UNITED STATES PATENT AND TRADEMARK OFFICE

APPLICATION NO.	FILING DATE	FIRST NAMED INVENTOR	ATTORNEY DOCKET NO.	CONFIRMATION NO.
10/729,932	12/09/2003	Hui Chun Hsu	OP-094000506	2437
46103	7590	05/30/2008		
HDSL				
4331 STEVENS BATTLE LANE				
FAIRFAX, VA 22033				
EXAMINER				
DUONG, THO V				
ART UNIT		PAPER NUMBER		
3744				
MAIL DATE		DELIVERY MODE		
05/30/2008		PAPER

Office Action Summary**Application No.**

DETAILED ACTION

Figure A: The modified figure corresponds to figure 5 with limitation shown

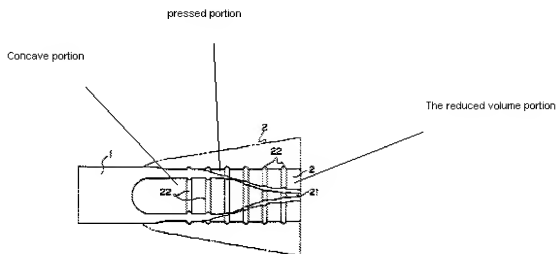
Claims 1 and 8-10 are rejected under 35 U.S.C. 102(b) as anticipated by Yumiko et al. (JP 406106269A). Yumiko discloses (figures 1-10 and figure A below) a circular tubular heat pipe having a sealed structure closing a distal opening end thereof, comprising a concave wall portion formed on the heat pipe bellow and near the distal opening to form an overlapping wall from the concave wall portion to the distal opening; a pressed recess portion formed on the concave wall portion adjacent to the distal opening, the pressed recess portion being an arch shape in cross section (see figure 4 and 7); wherein the pressed recess portion near the distal end

opening is inward pressed to form a volume reduced portion (21 in figures 5 and 7); and a sealed welding portion (2) formed at the pressed recess portion, the reduced volume portion and the distal end portion by ultrasonic welding forming spots (22) (figure 2). Furthermore, regarding claims 9-10, the methods of forming the device "is spot welded" and "is ultrasonically welded" are not germane to the issue of patentability of the device itself. Even though product-by-process claims are limited by and defined by the process, determination of patentability is based on the product itself. The patentability of a product does not depend on its method of production. If the product in the product-by-process claim is the same as or obvious from a product of the prior art, the claim is unpatentable even though the prior product was made by a different process." In re Thorpe, 777 F.2d 695, 698, 227 USPQ 964, 966 (Fed. Cir. 1985). In this instant case, the product-by-process claim is the same as or obvious from the heat pipe of Yumiko, the claim is unpatentable even though the prior product was made by a different type of welding. With respect to the limitation of "a volume reduced portion having a cross section of an unsymmetrical curled shape", Yumiko discloses (figure B) that the volume reduced portion having a cross section of an unsymmetrical curled shaped along its X-axis, where above and bellow cross section of the reduced portion along X-axis is different.
